FIELD ORDER SUMMARY

Project: Saranac Lake Gas Co. Remedial Action	Project Location: Village of Saranac Lake, Essex County, New York
Client: NYSDEC	NYSDEC Site No.: 516008
Contractor: LAND Remediation, Inc.	MACTEC Project No.: 3611181219

FIELD ORDER

Project Name:	Saranac Lake Gas Company, Remedial Action	FO No.: 1
Project Location:	Village of Saranac Lake, Essex County, New York	Date Issued: 7/17/2018
		Site No.: 516008
Client:	New York State Department of Environmental Conservation (Department)	Contract No.: D010663
Contractor:	LAND Remediation, Inc.	Associated RFI or PCO: <input type="checkbox"/> RFI No. ___ <input checked="" type="checkbox"/> PCO No. 4 <input type="checkbox"/> None
MACTEC Project No.:	3611181219

1 LANDSCAPE PLAN
SCALE: 1"=20'

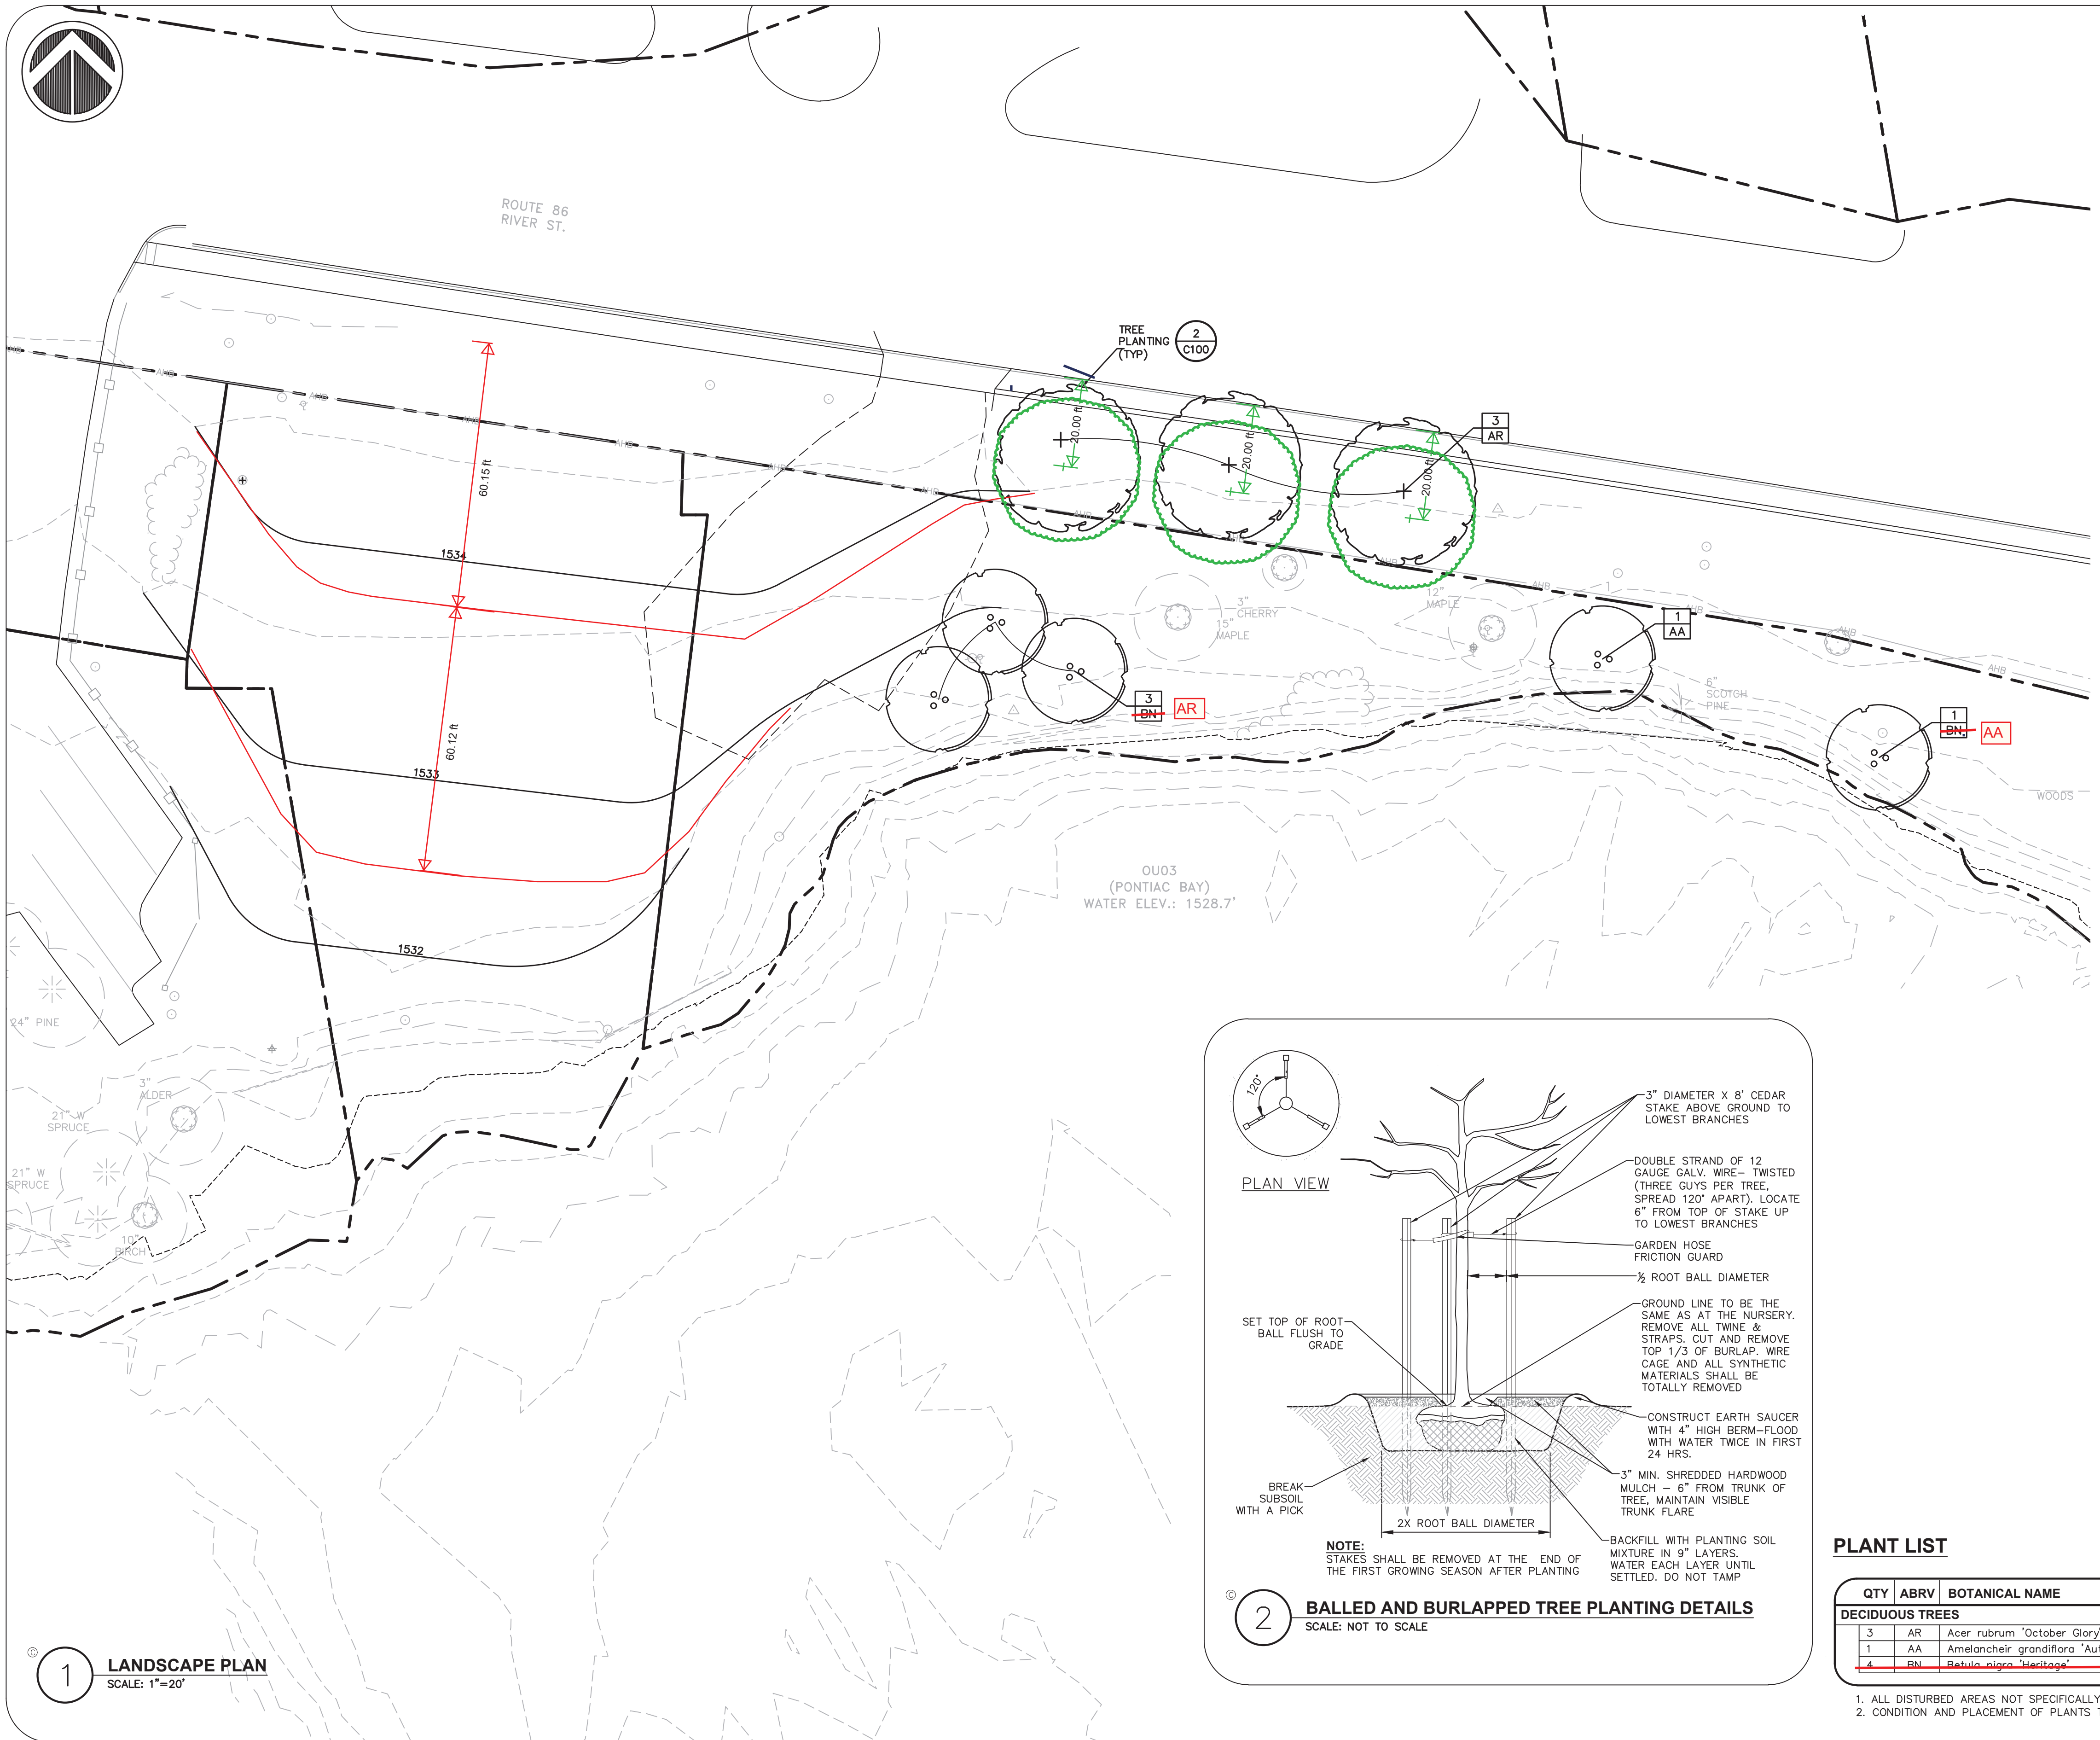
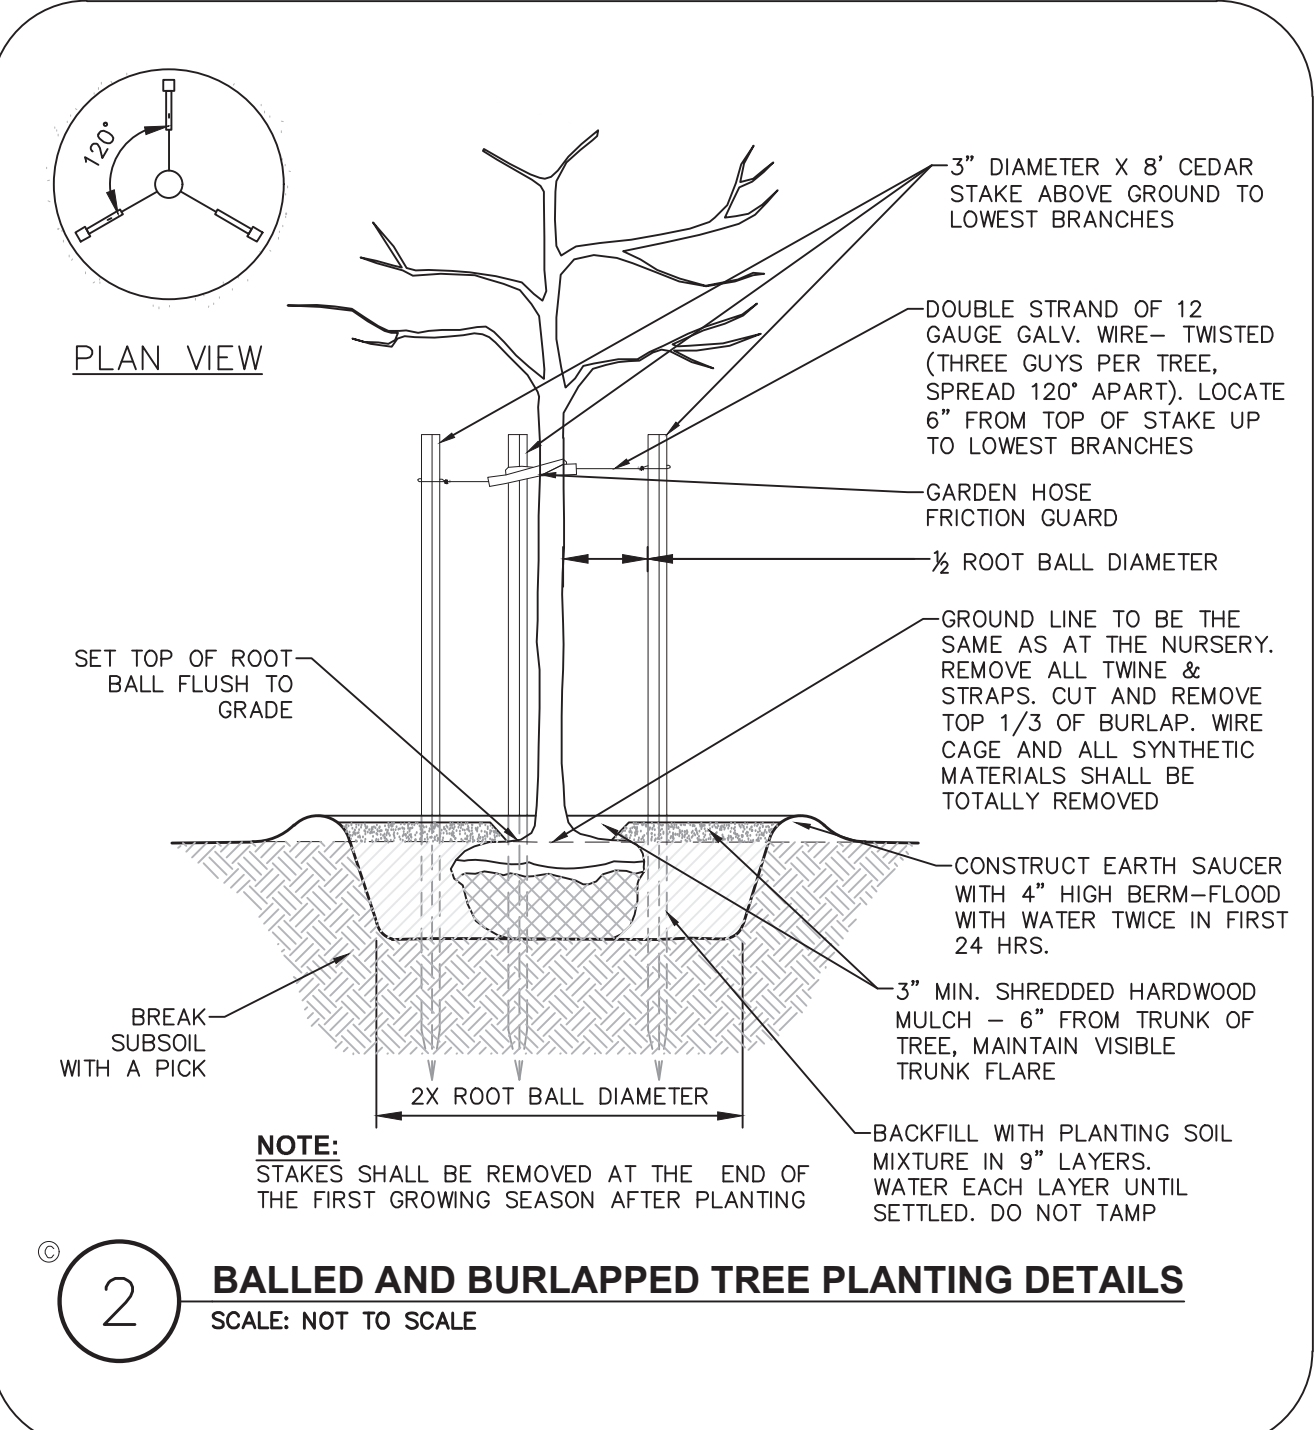
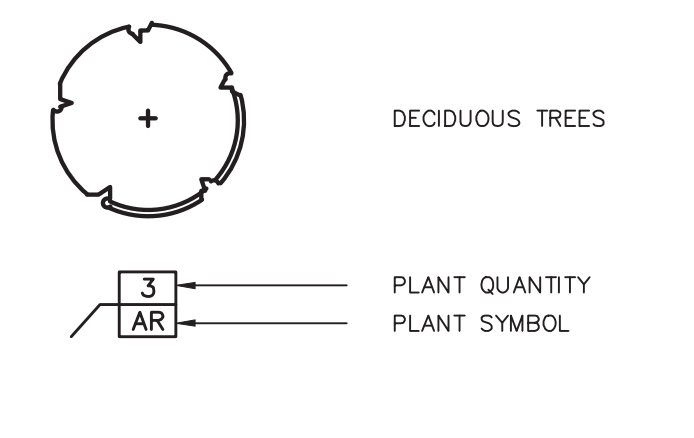
MACTEC Comments:
 This field order is being issued to ensure that the various changes agreed to between NYSDEC, the Village of Saranac Lake, and the Department of Transportation regarding the Prescott Park Landscaping Plan are completed accordingly. These changes are summarized via red and green mark-ups on the attached Prescott Park Landscape Plan, which was revised on November 2, 2018. The changes include: (1) slight change in grading that was incorporated prior to substantial completion, (2) moving three red maple trees a safe distance from River Street (~20 feet) to prevent damage from road salt, (3) replacing four heritage river birch trees with three red maples and one autumn brilliance.
